Re: Minor Project Refinement No. 1 for the TL 6975 San Marcos to Escondido Project.

TL6975 San Marcos to Escondido 69 kV Project CPUC Minor Project Refinement Form

Report No.: 1

Photograph 2:
View of the approximate location of the MPR-1 proposed work area, outlined in orange. Facing: NW

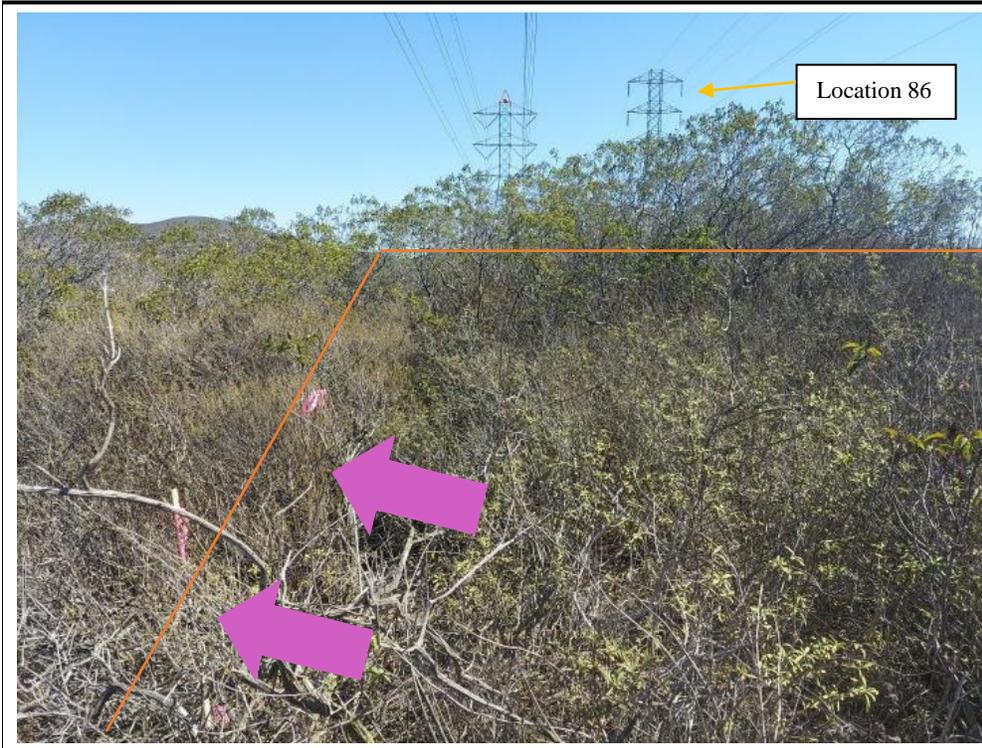
Justification for Change: Following constructability review in the field, the construction contractor identified the need to expand the approved snub site in order to safely and efficiently facilitate Segment 3 reconductoring activities. Existing lattice tower load constraints prevent conductor stringing through Location 85 and Location 86 without the use of a snub site. The snub site will allow space for equipment and construction personnel to pull, hold and splice conductor entering from the west at Location 85 and from the east at Location 86. These activities will reduce tension on the adjacent towers. Once the conductor is spliced at the snub site, it will be placed in a sleeve and raised into position under controlled tension. The total size of the requested MPR-1 work area has therefore been designed so that the angle required for adequate tension can be achieved for the line from both directions. The angle required for adequate tension also requires that the wire pulling equipment be set up in line with the overhead conductor, which is the reason the snub site cannot be located within the existing access road.

New disturbance acreage: The proposed MPR-1 work area is approximately 65 by 200 feet. Not including the existing 35 by 50-foot work area, this results in 11,250 square feet (0.26 acre) of new temporary disturbance to CSS.
